Subject: Beaver Valley Power Station, Unit No. 2
BV-2 Docket No. 50-412, License No. NPF-73
Response to a Request for Additional Information
In Support of LAR No. 168

RESPONSE TO REQUEST FOR ADDITIONAL INFORMATION (RAI)
POSITIVE MODERATOR TEMPERATURE COEFFICIENT (PMTc)
FOR BEAVER VALLEY POWER STATION, UNIT NO. 2
DATED NOVEMBER 16, 2001
(LICENSE AMENDMENT REQUEST [LAR] NO. 168)

Figure 1

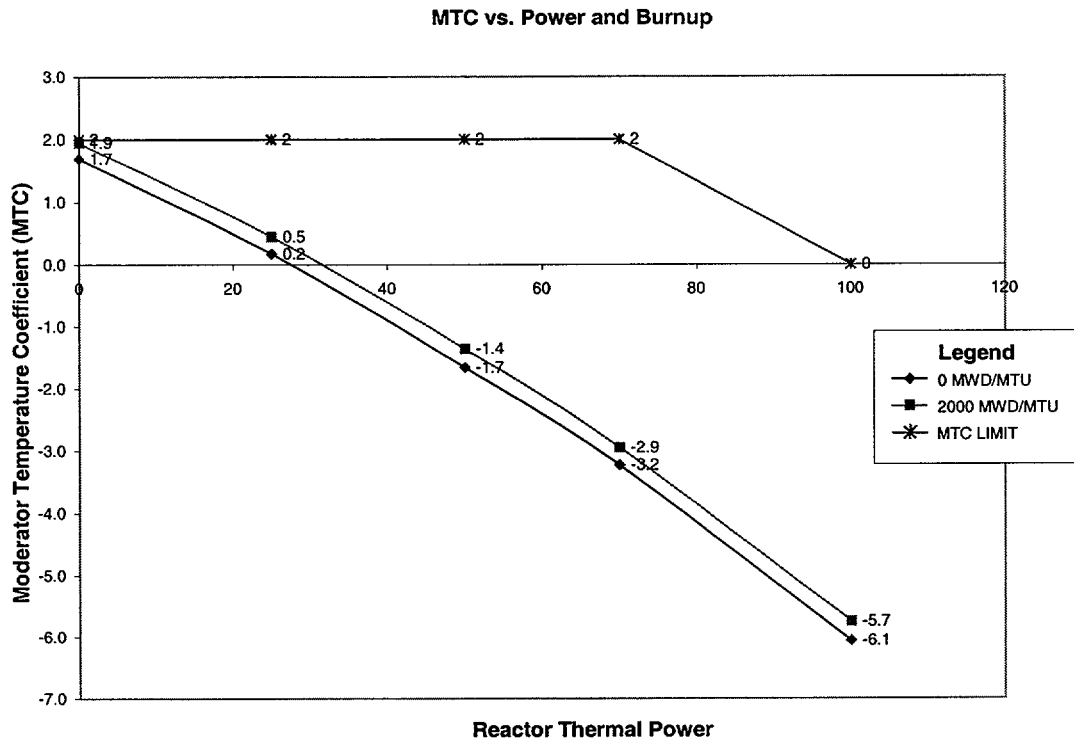
In response to [the August 2, 2001] NRC RAI Question 4, the licensee stated that BVPS-2 would have no unfavorable exposure time due to operation with a PMTC. The justification for this statement proposed by the licensee is that the MTC at hot full power (HFP) conditions will be less than -5.5 pcm/°F at all times in core life. The staff does not find the licensee's response and technical bases sufficient to support its position. In its initial RAIs, the staff noted there may be periods of time at the beginning of each cycle where the PMTC can cause BVPS-2 to exceed the ASME Stress Level C Limit of 3200 pounds-per-square inch absolute (psia) in the reactor coolant system (RCS) following an anticipated transient without scram (ATWS). This period of time will most likely occur during the initial startup of the plant following the refueling outage or any shutdown early in the core cycle that permits Xenon to decay. Please provide a quantitative analysis of the percentage of the cycle that BVPS-2 may be susceptible to exceeding the 3200 psia limit. In addition please provide a detailed descriptive summary of the methodology employed by FENOC to answer this question.

First, as indicated by the subject LAR, the proposed amendment limits the MTC to $+2$ pcm/ $^{\circ}$ F at part-power conditions from 0 to 70% power and linearly decreases from $+2$ pcm/ $^{\circ}$ F at 70% power to 0 pcm/ $^{\circ}$ F at 100% power. The MTC limit at 100% power remains the same as currently licensed for BVPS, Unit No. 2. This part-power positive MTC limit is illustrated in Figure 1 and is shown in comparison to the actual planned reload core MTC at the most limiting times in the cycle (i.e., between 0 megawatt days per metric ton uranium [MWD/MTU] and 2000 MWD/MTU burnup). As can be seen from Figure 1, the actual MTC meets the proposed $+2$ pcm/ $^{\circ}$ F limit at 0% power conditions and becomes negative at approximately 30% power. At 100% HFP conditions, the MTC is more negative than -5.5 pcm/ $^{\circ}$ F. Further note that the MTC versus power reflected in Figure 1 conservatively includes no Xenon.
